JUNE 16, 2021

TRI-CITY MEDICAL CENTER

TCMC MRI

BID ADDENDUM NO. 1

1 FIRST FLOOR DEMO - EAST

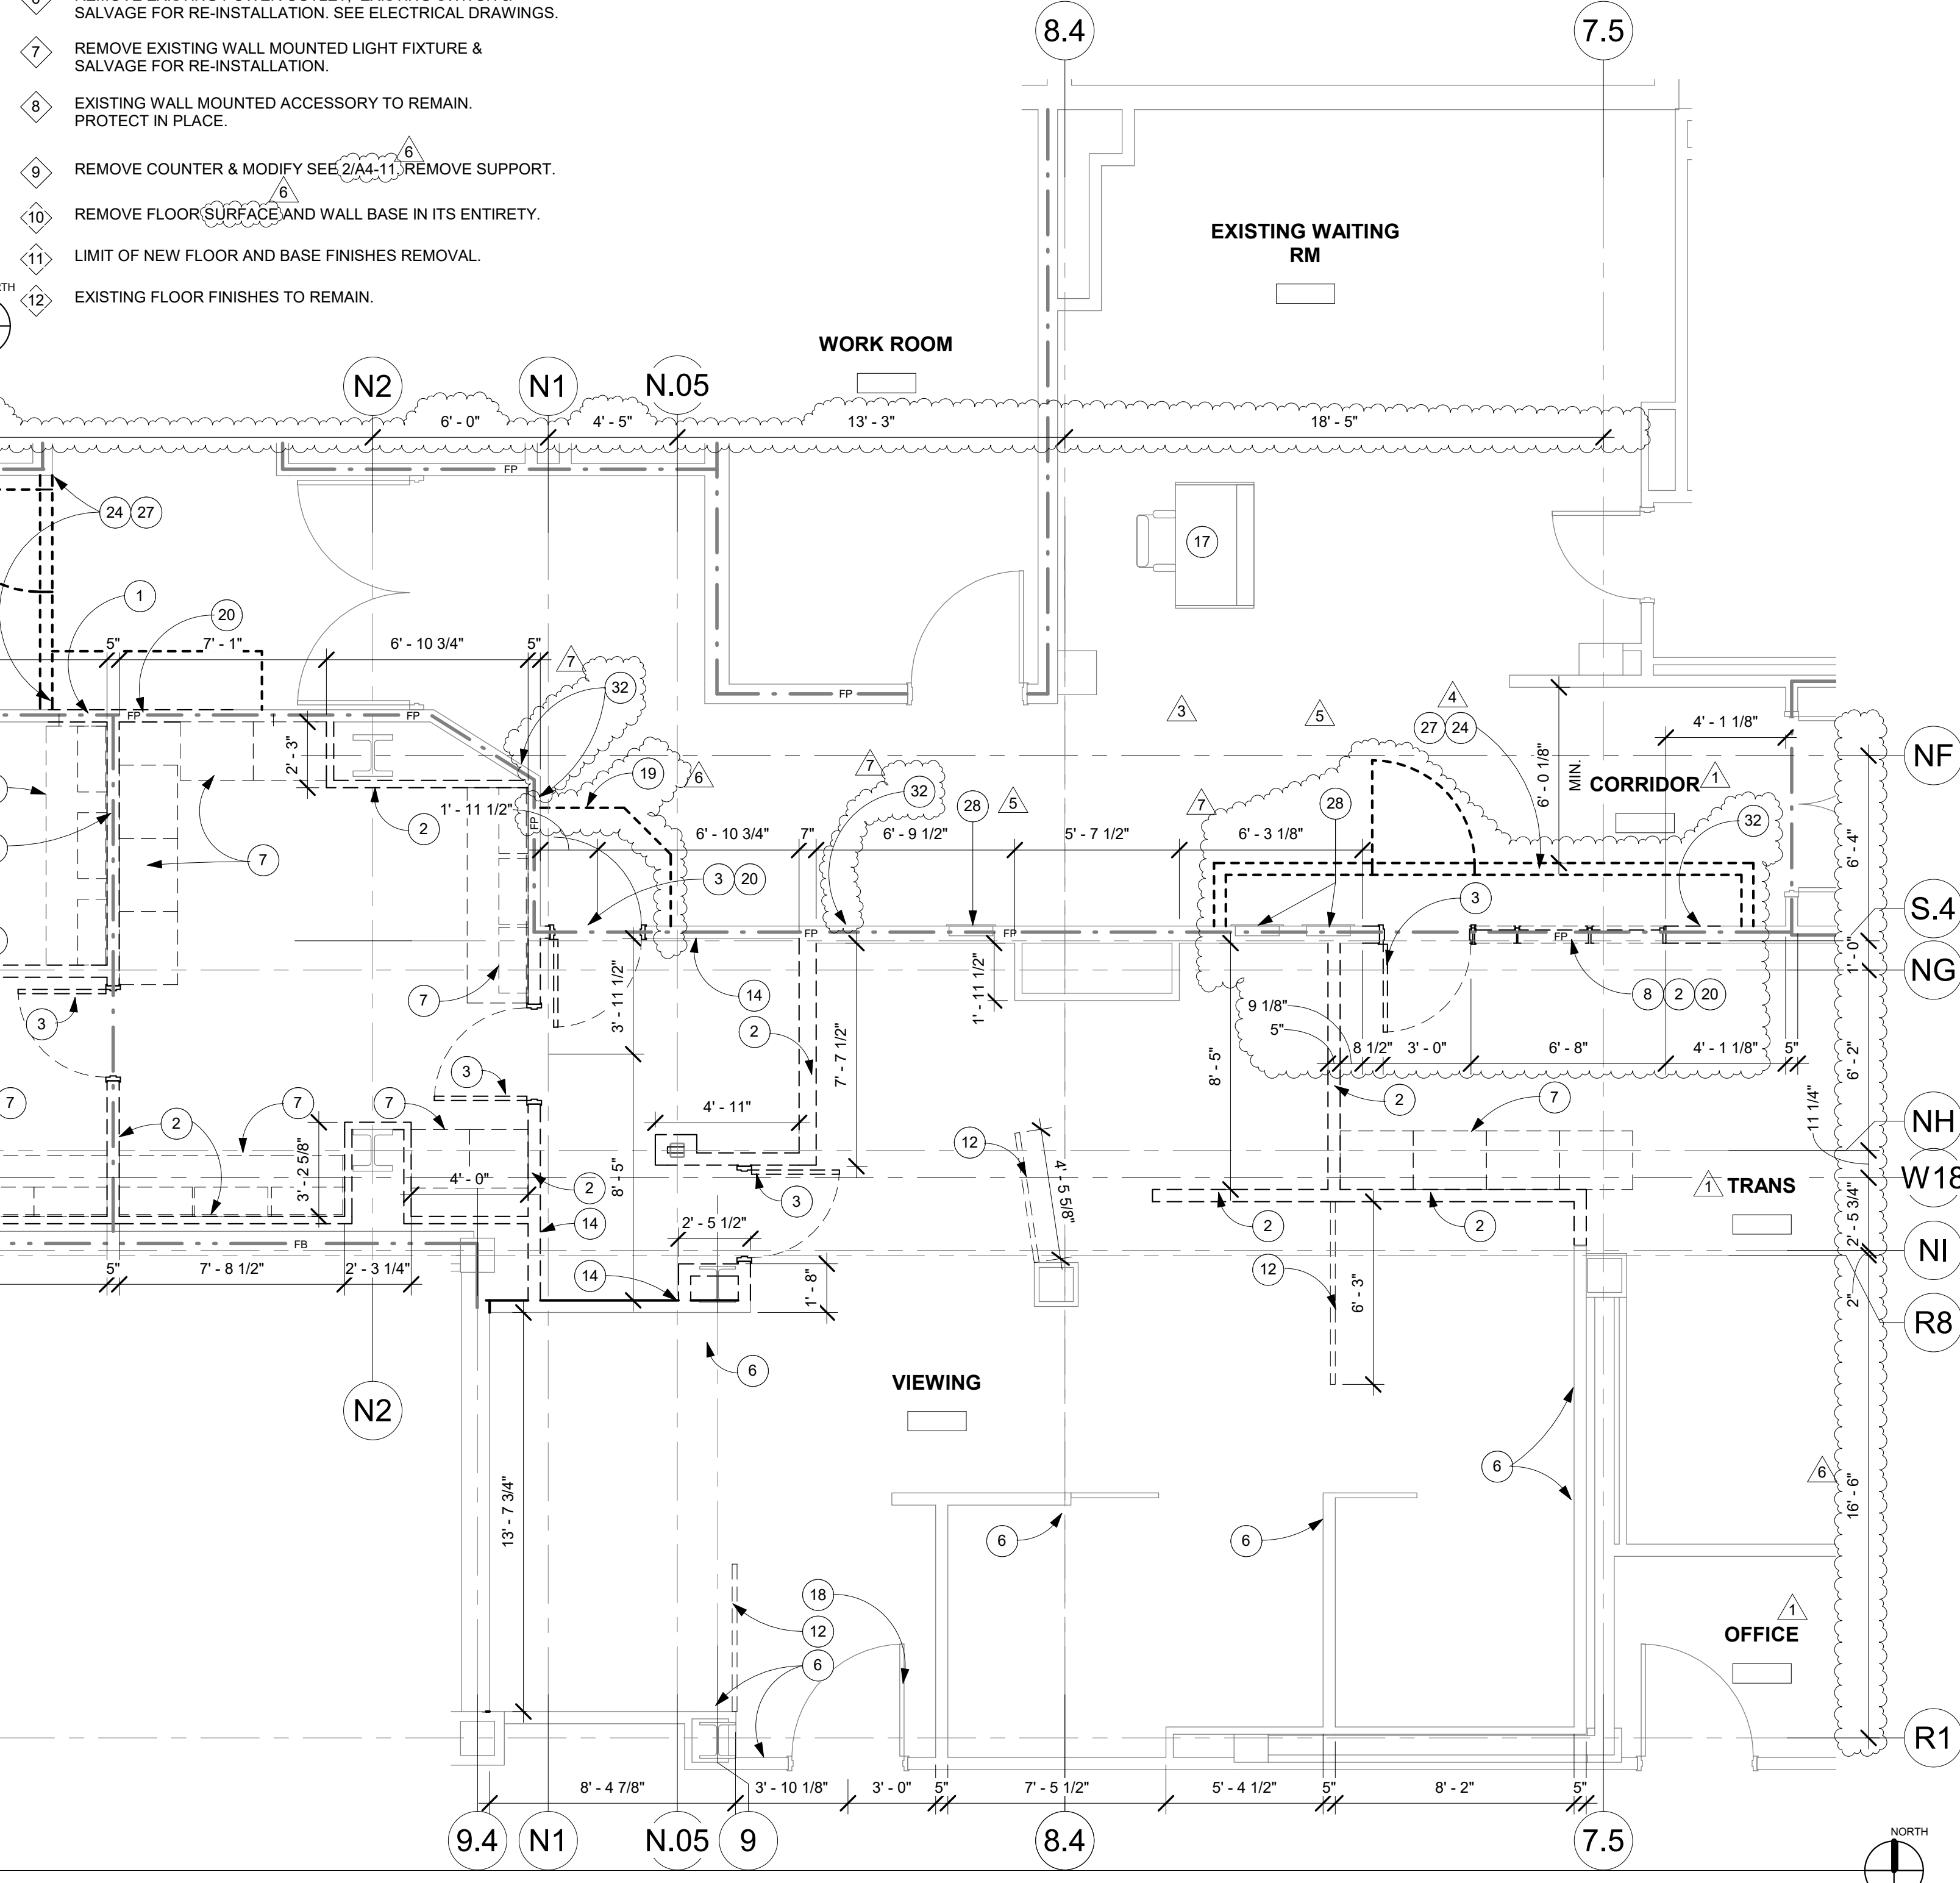
- Item No. 5 - Drawing A4-00:
- Add key note 33 to Demolition Key Notes: "Existing expansion joint to remain. Remove expansion joint cover."
- Add key note 33 to South West corner of existing office space to First Floor Demo – West as highlighted by delta 7.

- Add graphics and dimensions of existing to be demolished door and wall at 1/A4-01 separating Trans room and corridor.
- Item No. 9 - Drawing A4-01:
- Add key note 32 to Demolition Key Notes: "Remove wall paper and base in its entirety. Salvage bumper rails to be reinstalled."

- Add key note 32 to First Floor Demo – West in south side of corridor as highlighted by delta 7.
- Item No. 10 - Drawing A4-01:
- Delete graphics for saw cut between gridlines N2 and N3.

1 FIRST FLOOR PLAN - WEST
1/4" = 1'-0"

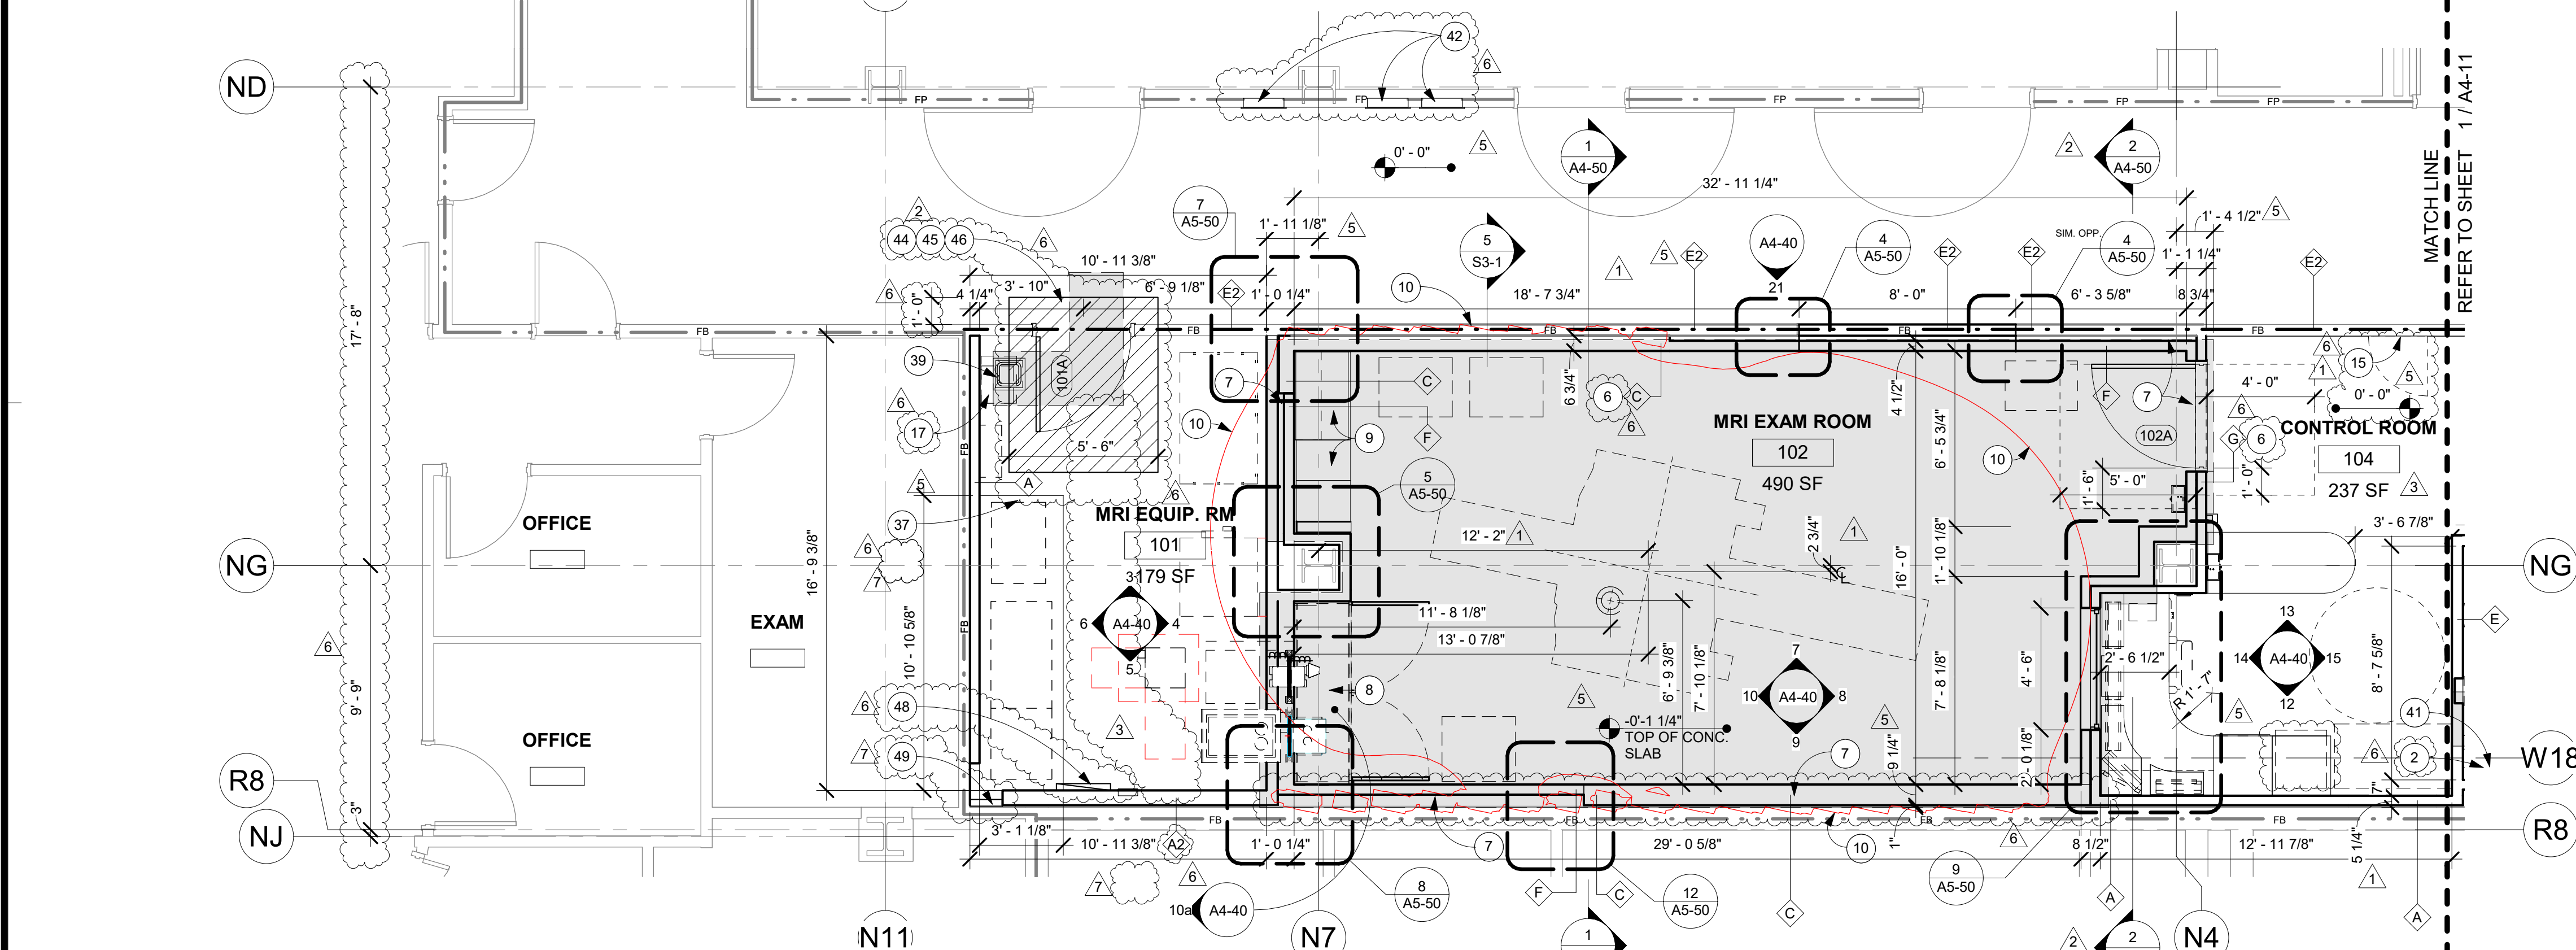
- Item No. 12 - Drawing A4-01:
- Add room tag "Office" to existing office space.
- Item No. 13 - Drawing A4-10:
- Add key note 49 to Floor Plan Keynotes: "Add expansion joint cover AFW-200 by construction specialties. Overall dimension 7"."

- Add key note 49 to South West corner of new MRI Equipment Room.
- Extent of new wall fur out is on west side of MRI Equipment Room wall is revised.
- Item No. 14 - Drawing A4-10:

- Delete floor sink on south side of MRI Equipment Room.
- Delete portion of concrete infill associated with deleted sanitary sewer.
- Item No. 15 - Drawing A4-10:

1 FIRST FLOOR PLAN - EAST
1/4" = 1'-0"

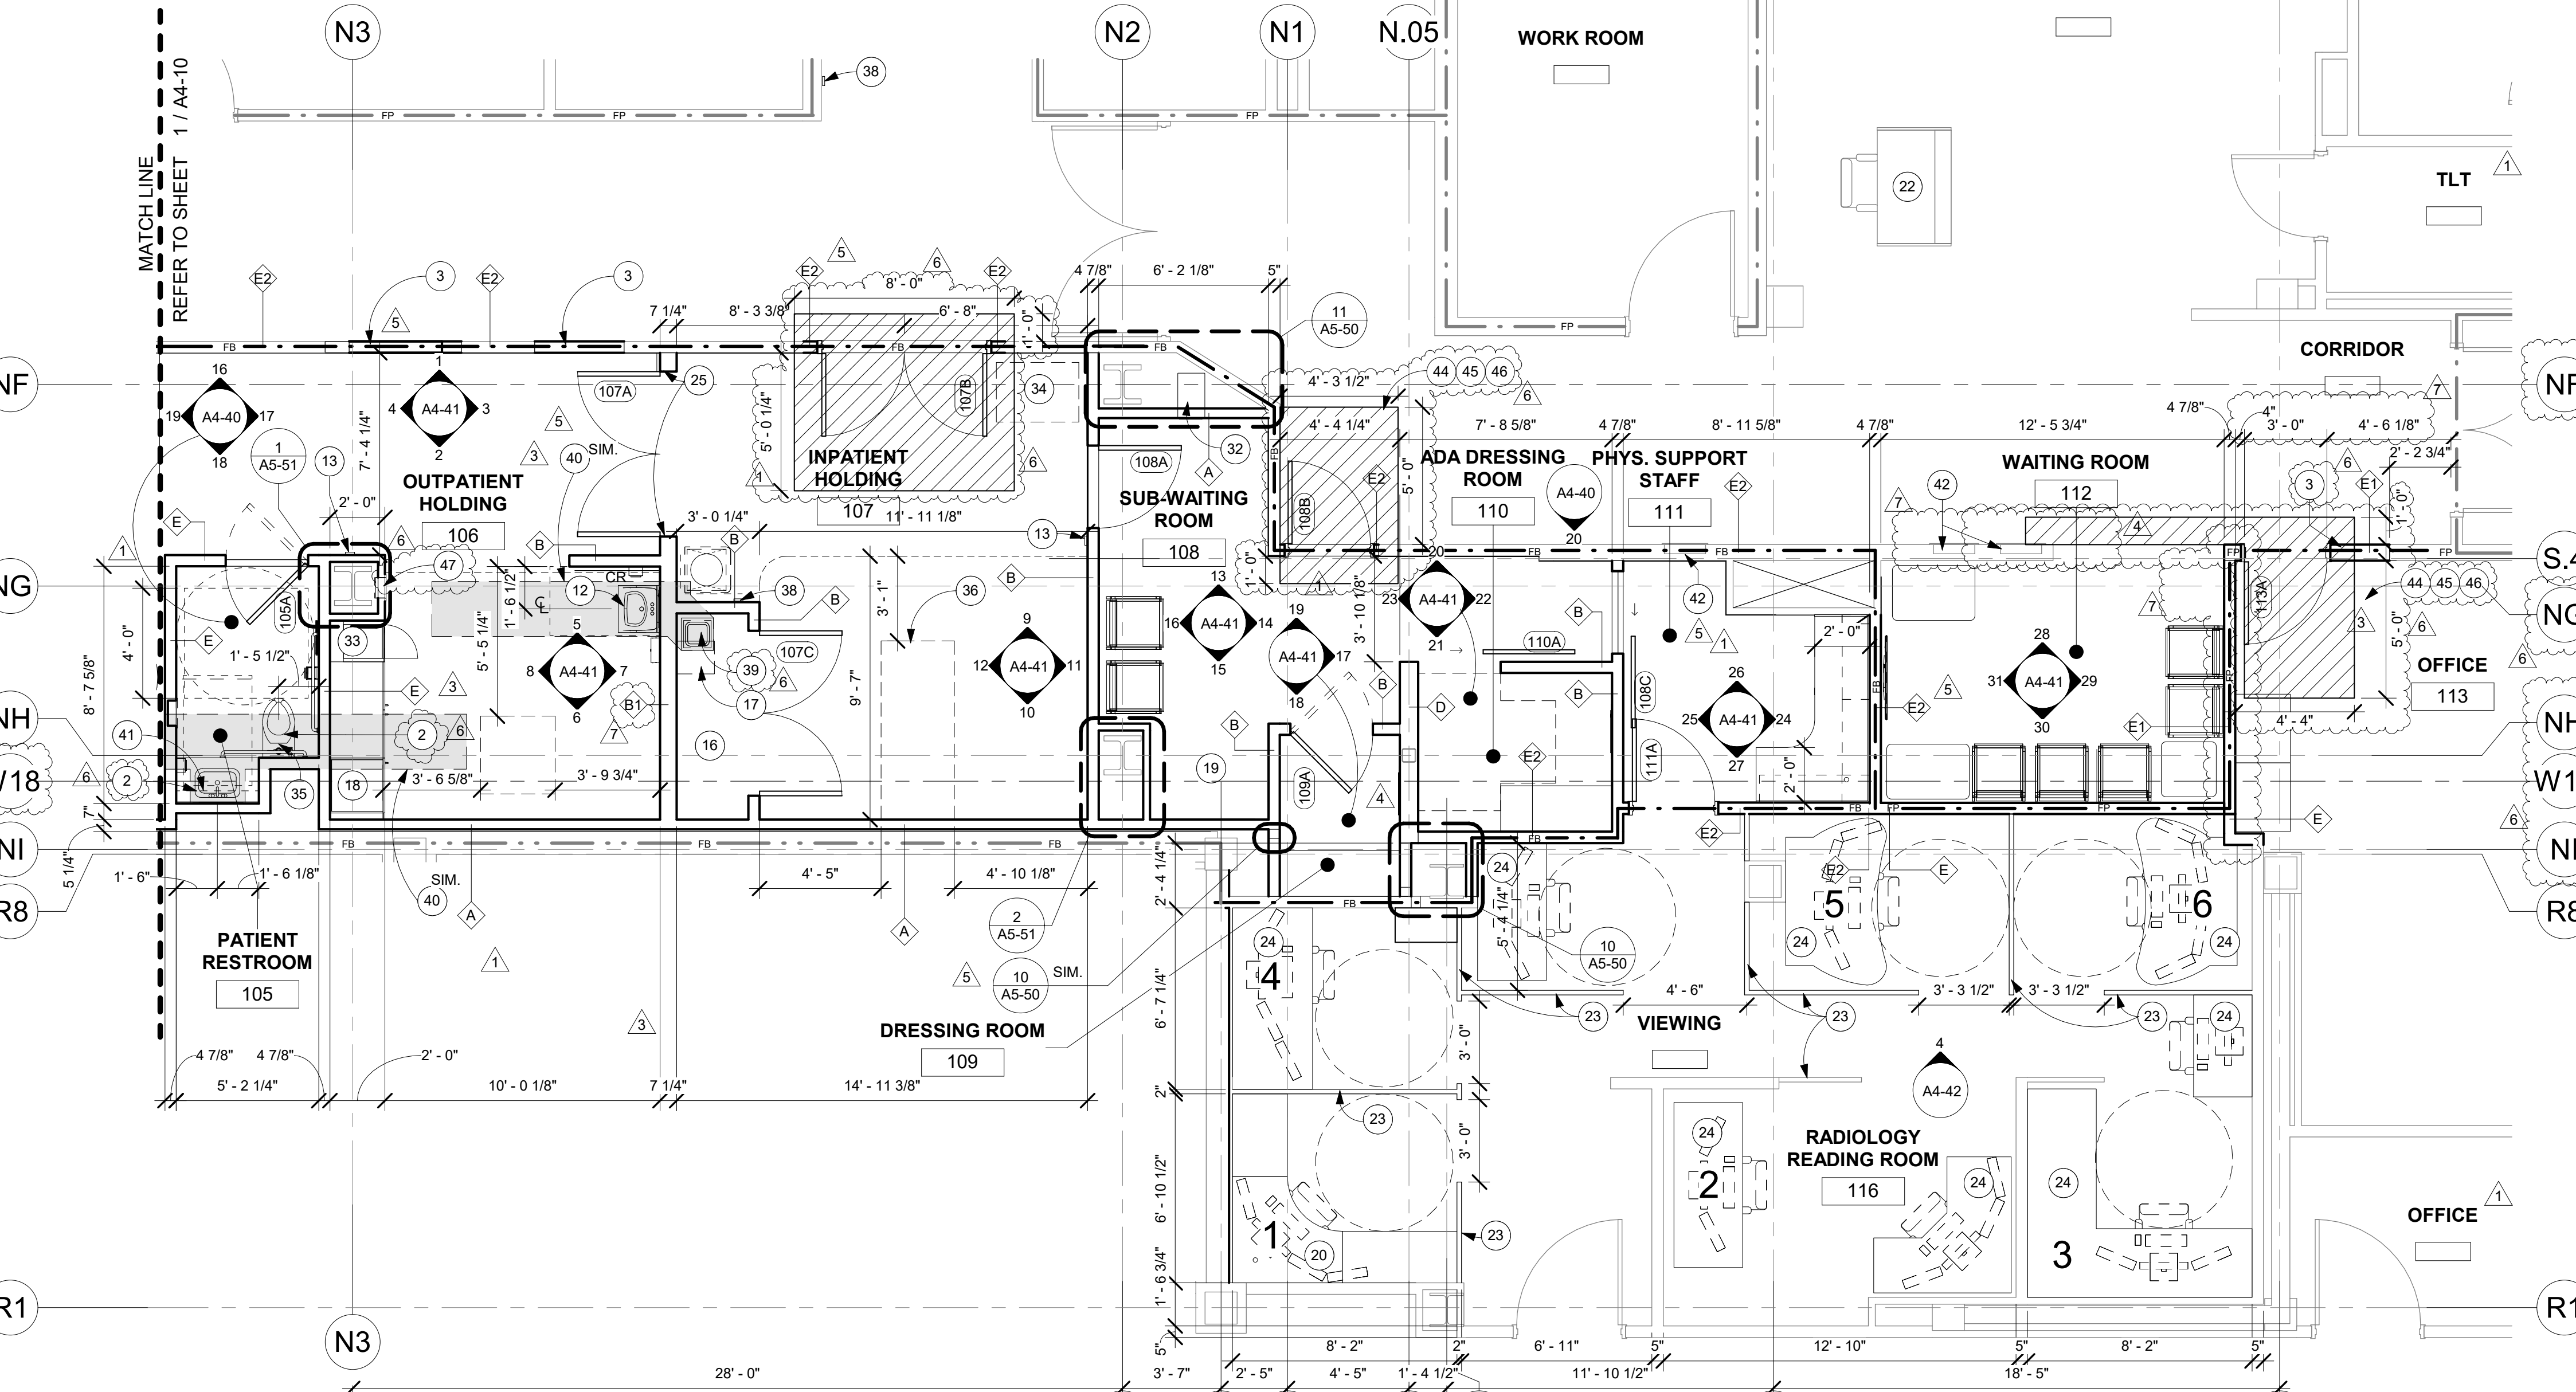
- Item No. 16 - Drawing A4-11:
- Delete new wall between inpatient and outpatient holding with wall tag "B" as highlighted in plan with delta 7.
- Add new wall between inpatient and outpatient holding with wall tag "B1" as highlighted in plan with delta 7.

- Item No. 17 - Drawing A4-11:
- Delete new wall between new waiting room and existing office 113.
- Add new wall between new waiting room and existing office 113 as highlighted in plan with delta 7.

- Item No. 18 - Drawing A4-11:
- Delete one chair from new waiting room.
- Item No. 19 - Drawing A4-20:
- Add room tag "Office" to existing office space.
- Item No. 20 - Drawing A4-20:
